BRUSH CREEK 3RD ADDITION

Re: S/D 98-26 -- One-Step Final Plat of BRUSH CREEK 2ND ADDITION

Re: S/D 98-26 -- One-Step Final Plat of BRUSH CREEK 2ND ADDITION

CASE NUMBER: S/D 98-26 - BRUSH CREEK 2nd ADDITION

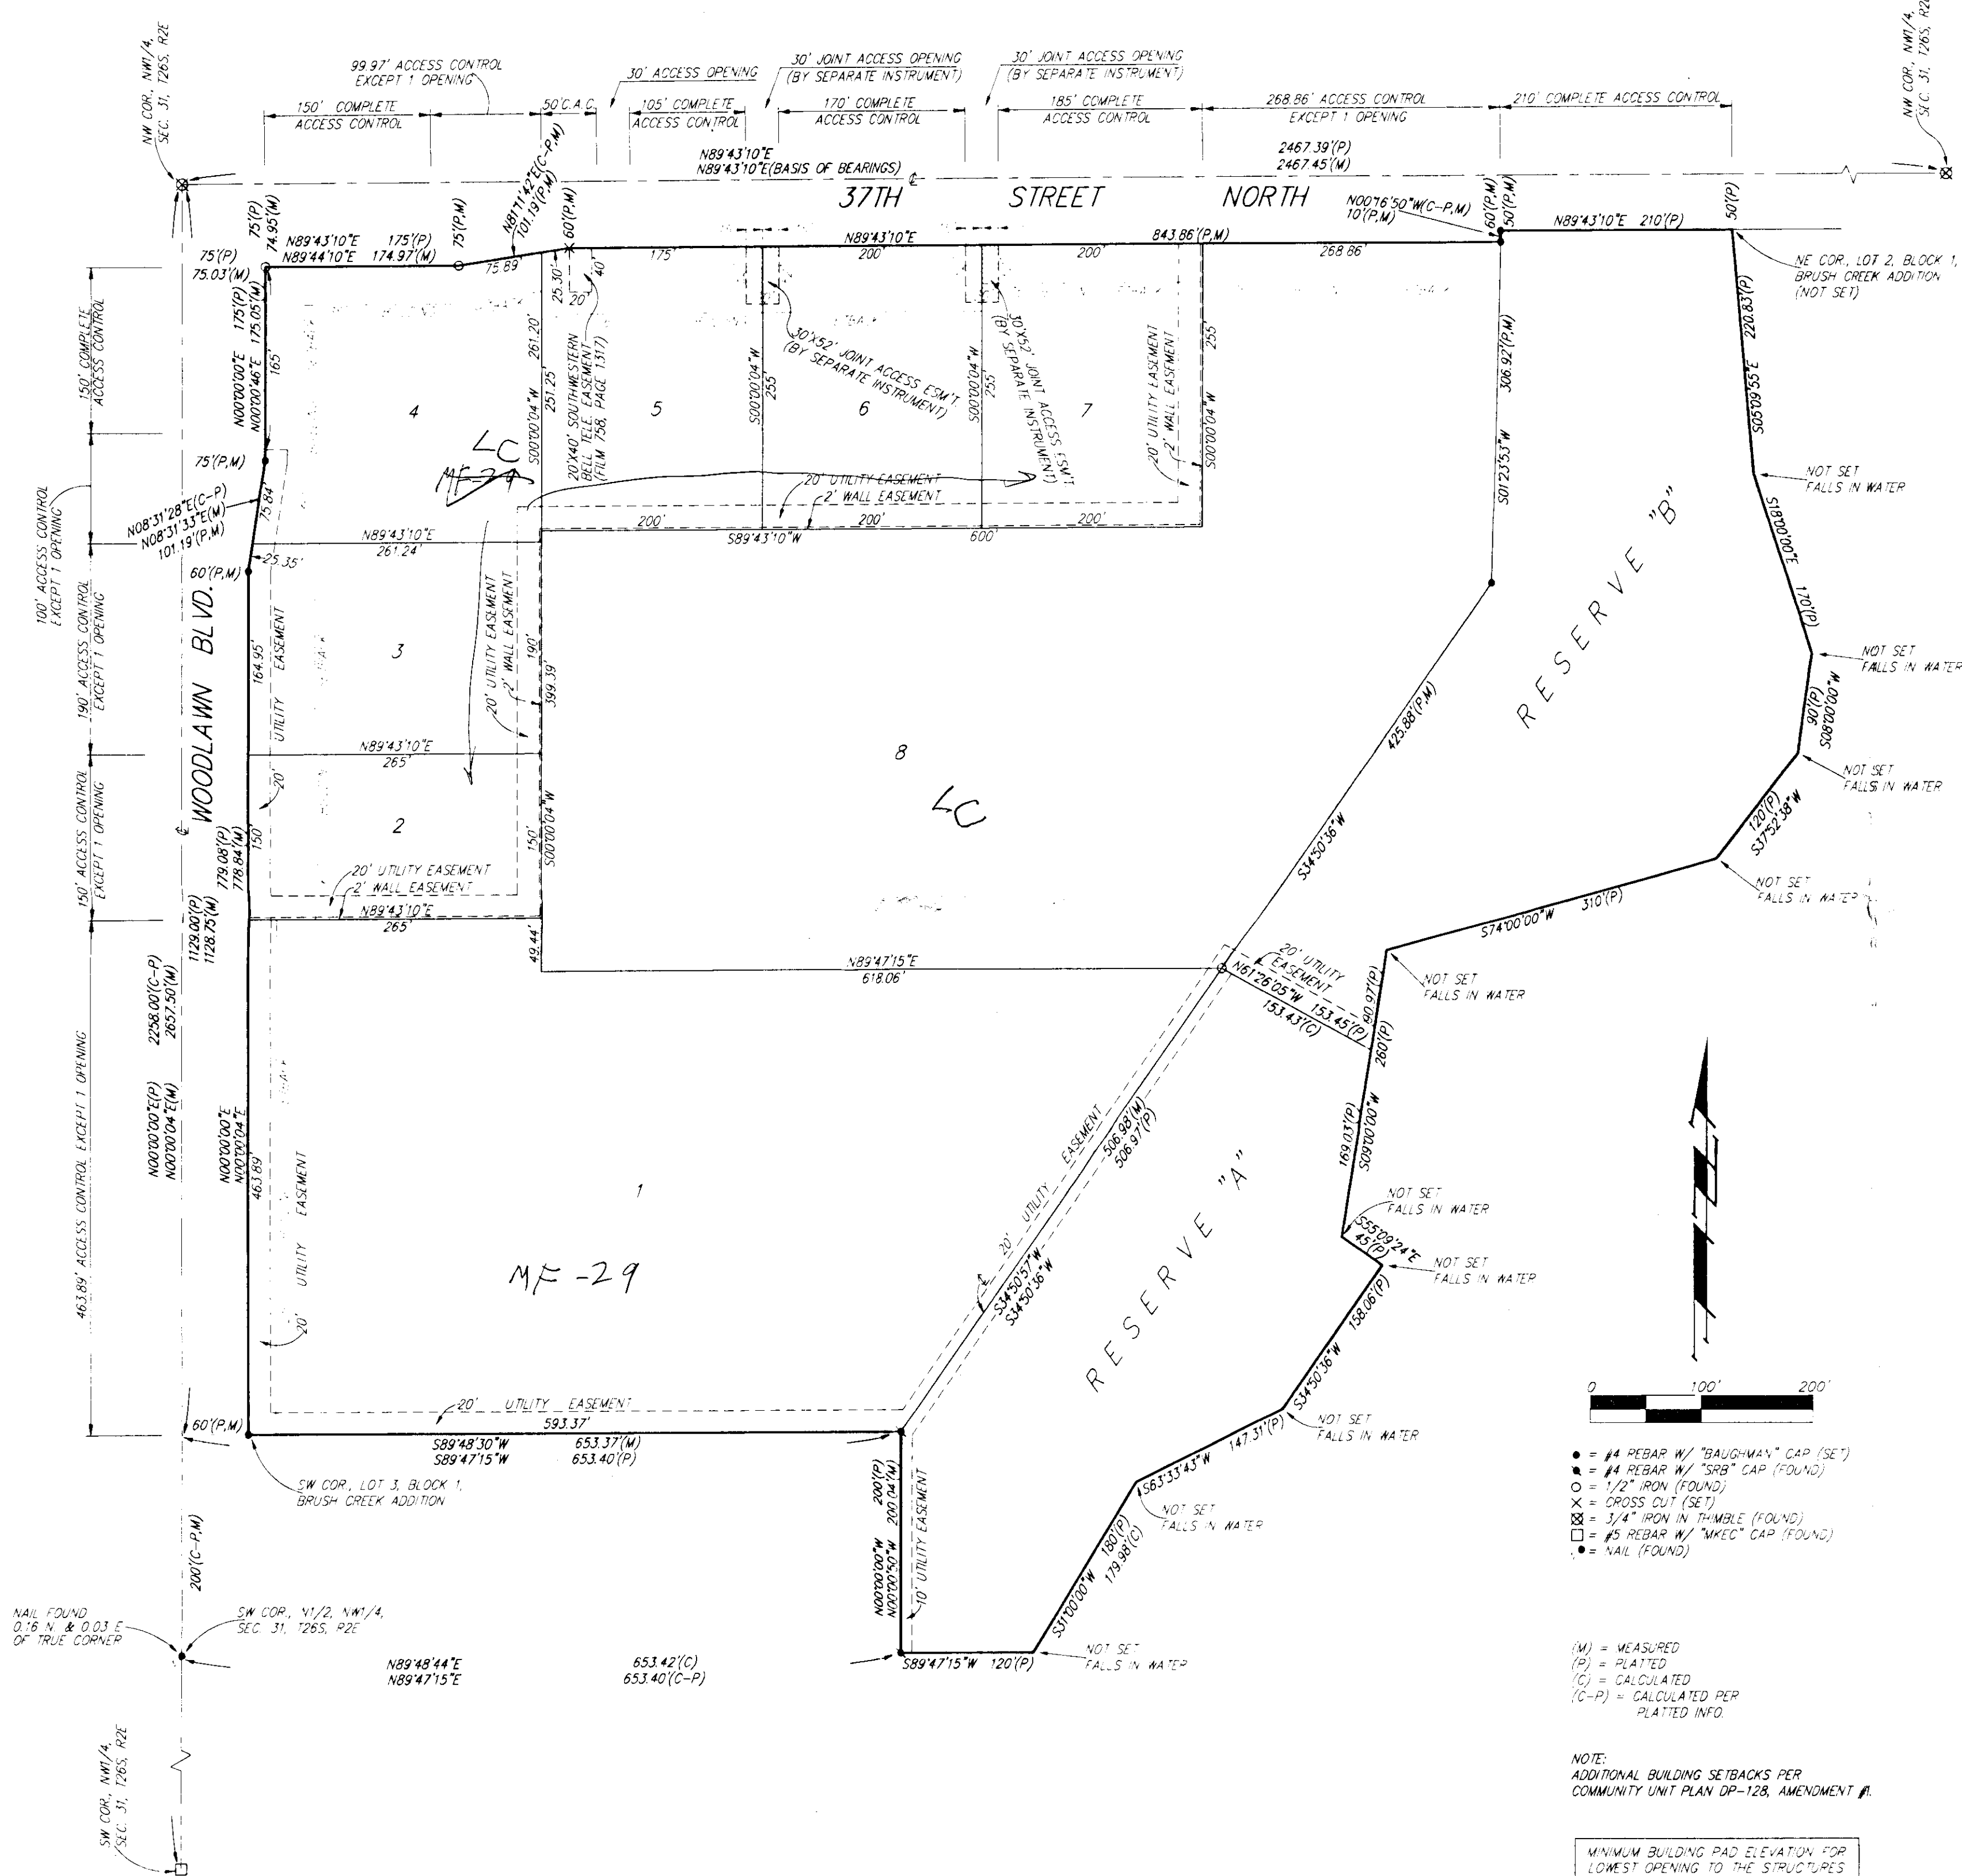
- A. Existing municipal services appear to be available to this site. City Engineering needs to indicate if any other guarantees are required. **A guarantee for sanitary sewer extension is required. A cross-lot drainage agreement is required.**

- C. The final tracing should be submitted with a revised name as an Addition now exists with the name "Brush Creek 2nd Addition".
- D. City Engineering needs to comment on the status of the applicant's drainage plan along with the minimum building pad elevations denoted on the plat. **A guarantee for drainage improvements will be required.**

- E. A condition of the CUP was that the access controls *would* be determined at the platting stage. The plat denotes one access opening for the multi-family lot (Lot 1) along Woodlawn. Lots 2, 3 and 4 are platted with one opening for each lot along Woodlawn. Five openings along 37th Street North have been denoted on the plat. The Subdivision regulations encourage shared access points for multiple lot commercial subdivisions along arterials. Traffic Engineering needs to comment on the recommended location of said joint access openings. **Traffic Engineering has approved the access controls as platted.**

- F. The plat shall denote 150 feet of complete access control at the corner of the intersection of Woodlawn and 37th St. North.
- G. The required joint access openings will need to be established by separate instrument. Initial construction responsibilities and future maintenance of the driveway within the easement should also be addressed by the text of the instrument.

- J. On the final plat tracing, since the site is within the City limits of Wichita, the platlor's text shall note that the access controls are being dedicated to the City of Wichita and that the location of the openings are subject to the approval of the City Engineer. Distances should be shown for all segments of access control.

- L. For the reserves being platted for drainage purposes, the platlor's text shall include language that grants to the City the authority to maintain the drainage reserves in the event the owners fail to do so. The covenant shall provide for the cost of such maintenance to be charged back to the owner(s) by a method similar to special assessments.

- N. The final plat tracing shall reference a tie point to a section corner.
- O. The applicant shall install or guarantee the installation of all utilities and facilities which are applicable and described in Article 8 of the MAPC Subdivision Regulations. (Water service and fire hydrants required by Article 8 for fire protection shall be as per the direction and approval of the Chief of the Fire Department.)

- V. The representatives from the utility companies should be prepared to comment on the need for any additional utility easements to be platted on this property. **Southwestern Bell has requested additional easements.**

- X. The applicant has indicated a revision in lot sizes will be denoted on the final plat tracing, and a CUP adjustment will be requested. The north-south dimension of Lot 2 will be revised from 173 to 150 feet. Ten (10') feet of Lot 8 will encroach into Lots 5, 6, and 7.**
